SUTHERLAND SHIRE COUNCIL ASSESSMENT REPORT

Panel Reference	2018SSH036
DA Number	DA18/0884
LGA	Sutherland Shire
Proposed Development	Demolition of existing structures, construction of 2 residential flat buildings containing 114 units under the Affordable Rental Housing SEPP and 2 lot stratum subdivision
Street Address	678, 680, 682 Kingsway, Miranda, 11, 13 Pinnacle Street, Miranda
Applicant/Owner	Altis Bulky Retail Pty Ltd As Trustee For Altis Aret Sub Trust 8
Date of DA lodgement	24 July 2018
Number of Submissions	10
Recommendation	Approval
Regional Development Criteria (Schedule 7 of the SEPP (State and Regional Development) 2011)	Affordable Rental Housing component exceeding \$5 million
List of all relevant s4.15(1)(a) matters	<ul style="list-style-type: none"> • <i>State Environmental Planning Policy (State and Regional Development) 2011</i> • <i>State Environmental Planning Policy No. 55 – Remediation of Land.</i> • <i>Draft State Environmental Planning Policy (Remediation of Land) (draft Remediation of Land SEPP)</i> • <i>State Environmental Planning Policy (Building Sustainability Index: BASIX) 2004</i> • <i>State Environmental Planning Policy (Infrastructure) 2007.</i> • <

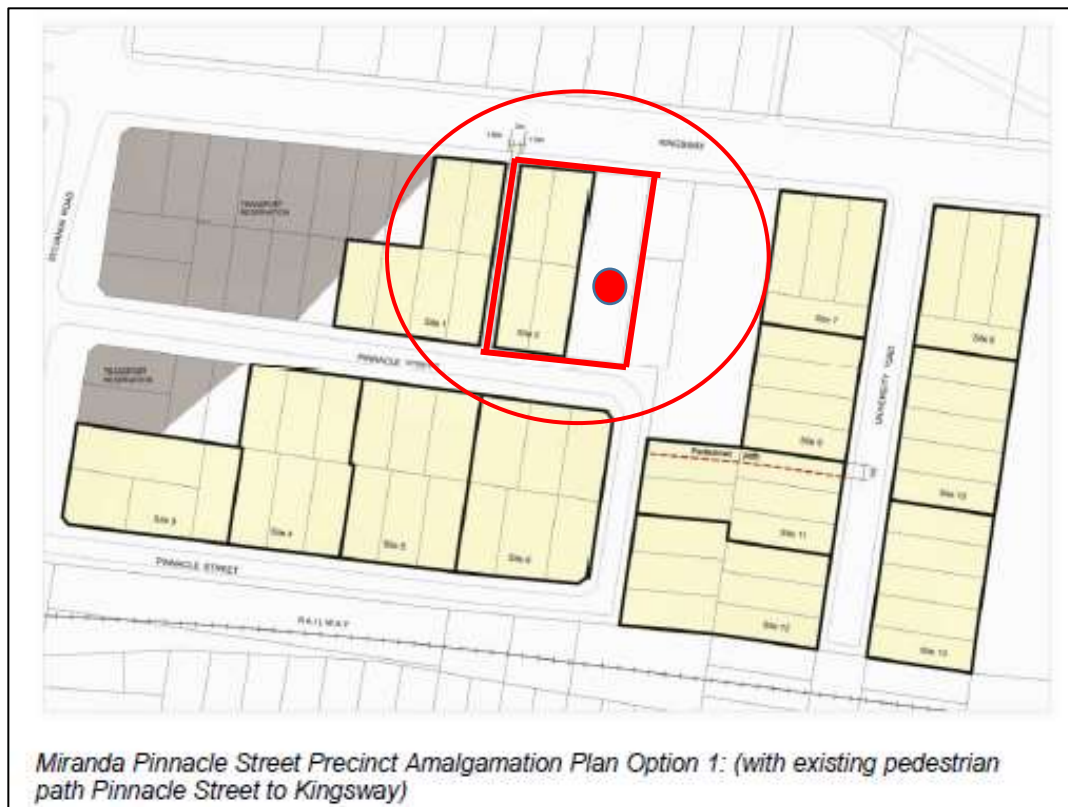
As part of the applicant's submission, reference is made to a prior development approval by the Land & Environment Court (LEC) of a Council refused development scheme on part of this site (DA16/1411). The approval entails an 8 storey building on the lots fronting the Kingsway and a 3 storey building form extending to Pinnacle Street (over 9 Pinnacle Street). Sites at No. 11 and 13 Pinnacle Street were excluded from this scheme. In support of this proposed 7 storey building B form, the applicant indicates that the LEC considered building heights on excluded lots based on the LEP height of 25m and the DCP with its envelopes over part of the site and determined that development was feasible and relied on plans in evidence showing 7-8 storey buildings on the Pinnacle Street fronting sites. It is Council's view that the Court accepted that it was only necessary for the applicant to demonstrate that there are feasible options for the development of these adjoining sites and that it need not provide a more detailed hypothetical development proposal akin to what one would expect with a development application. The considered height should not be an automatic precursory approval / or an acceptable outcome in support for building height under this Development Application. The information relied upon is considerably merely an exercise in demonstrating feasible opportunity so as to not unduly inhibit development on excluded lots, rather not being a detailed assessment of the merits of such building forms in the context of the locality and having

regard to the character of the streetscape. Further, the LEC considered plans would also present a different form and character outcome, including relationship to adjacent development(s) if realised, in contrast to this proposal being a broad building form on a larger consolidation of allotments.

The applicant also indicates that a reduction in the height of Building B below 7 storeys would create an unviable scenario to achieving the 0.5 ARHSEPP FSR bonus, a critical component to achieving 50% affordable housing (another public benefit for the proposal -providing greater access in Miranda to more affordable housing in proximity to public transport). Whilst the public benefit is undeniable, this as a consideration alone to justify the breach in LEP building height and the scale and nature of Building B having regard to the character of the Pinnacle Streetscape is not accepted.

The applicant's submission with respect to Building B fails to demonstrate that compliance with the building height development standard is unreasonable or unnecessary in the circumstances of the case and does not demonstrate sufficient environmental planning grounds to justify varying this development standard. In terms of scale, Building B is not in the public interest as the proposal fails to achieve compliance with the objectives for both height and the R4 – High Density Residential zone. There is a public benefit associated with reducing the height of the development to comply with the development standard (in the circumstances of this case). In conclusion the variation to the height development standard with respect to Building B fails to satisfy the relevant parts of clause 4.6, therefore the variation cannot be supported.

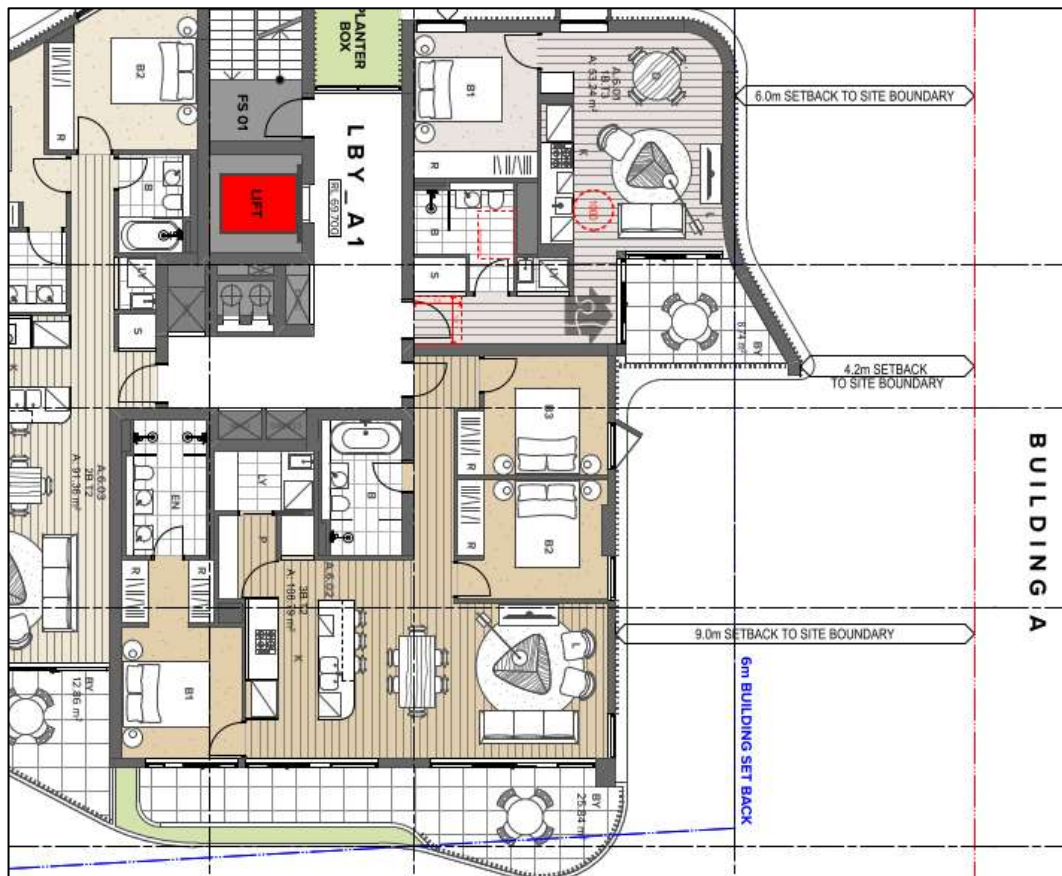
Amalgamation of 'Site 2' with an eastern adjoining site (as proposed) was not envisaged under SSDCP1015. Whilst omitted from the Precinct strategy, the remaining sites to the east (denoted in 'grey' in the diagrams above) are located within the same Zone, permitted to the same maximum height and density under SSLEP2015 and would be capable of amalgamation to a larger development site. Development is not anticipated to be unduly isolated or inhibited by the proposed development incorporating the additional site.

As previously discussed, the proposal does not respond in full to the desired character of this locality which is the main test to overcome when developing pursuant to the ARHSEPP. The issue primarily lies with the Pinnacle Street Building B where the ARHSEPP floor space bonus sought above SSLEP2015 results in a building significantly exceeding 4 storeys as envisaged under the Potential Built Form. It is noted that the desired future character for high density residential development in this Precinct is 2:1 which is evidenced by recent approved / constructed developments. Realising the full permitted floor space bonus under the ARHSEPP is proven difficult and not likely to be possible in this instance. The recommended reduction in height would enable the development to better relate to the scale of development on the existing eastern adjoining properties and set suitable cues for four storey building forms to be constructed as envisaged along the northern side of Pinnacle Street.
